### **AMENDMENTS TO THE DRAWINGS**

### REMARKS

U.S. Application Serial No. 10/693,329  
Attorney Docket: 46675-0005  
Reply to Office Action of August 23, 2005

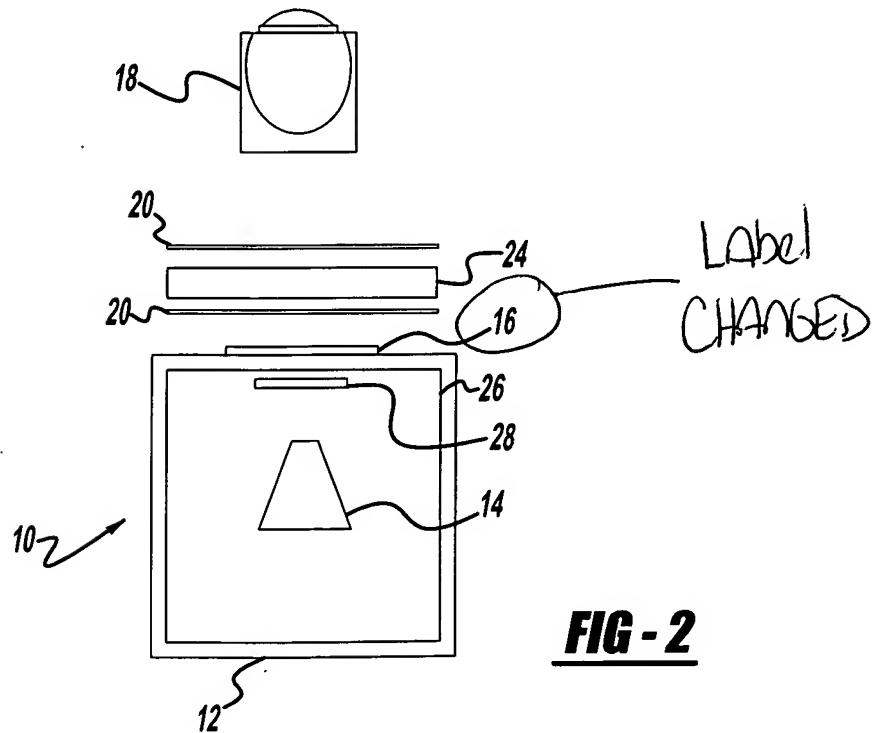
The attached sheets of drawings include changes to Figures 1, 2 and 4-6 and replace the original sheets. In Figure 1, previously mislabeled element 15 has been changed to 16. In Figure 2, previously mislabeled element 10 has been changed to 16. In Figures 4-6, element 34 has been reinserted into the formalized drawings. Furthermore, arrow 40 has been added to Figures 4 and 5.

The Examiner has objected to the drawings for failing to comply with 37 CFR 1.84(p)(5) and 37 CFR 1.84 (p)(4) for various reasons. Applicant has amended the drawings as follows: (i) in Figure 1, previously mislabeled element 15 has been changed to 16, (ii) in Figure 2, previously mislabeled element 10 has been changed to 16, (iii) in Figures 4-6, element 34 has been reinserted into the formalized drawings (which was included in the figures originally filed with this application), and (iv) arrow 40 has been added to Figures 4 and 5. Applicant respectfully requests that the Examiner withdraw his objections to the drawings.
